November 8, 2013

Re: Supplemental Information Regarding Celanese Clear Lake Plant Permit – No. PSD-TX-1296-GHG

Comparison of Reforming Processes

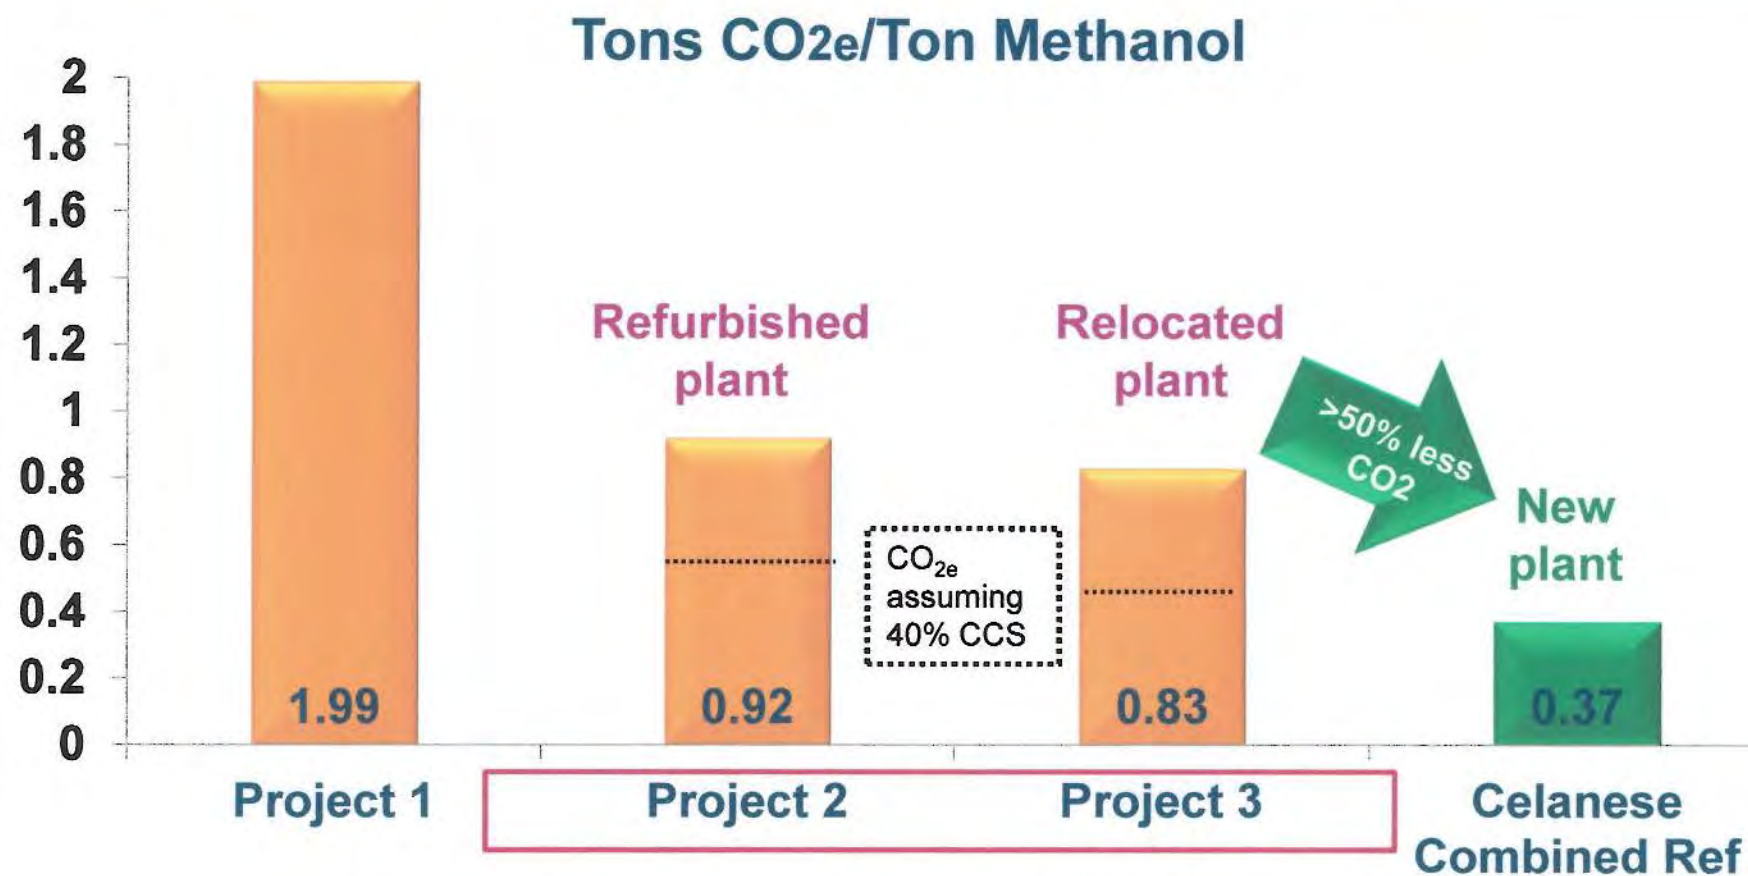
Celanese’s proposed process for methanol production at its Clear Lake Plant, a combined reforming process, is more efficient and would emit less CO₂ than the other methanol facilities recently permitted by EPA. In fact, as demonstrated by the enclosed graph, the combined reformer process would result in lower CO₂ emissions even if these other facilities added carbon capture and sequestration (“CCS”) to control CO₂ emissions. The significant emissions reductions that will be achieved by using this technology will set the new Best Available Control Technology (“BACT”).

Will be the lowest CO_{2e} emissions within the US
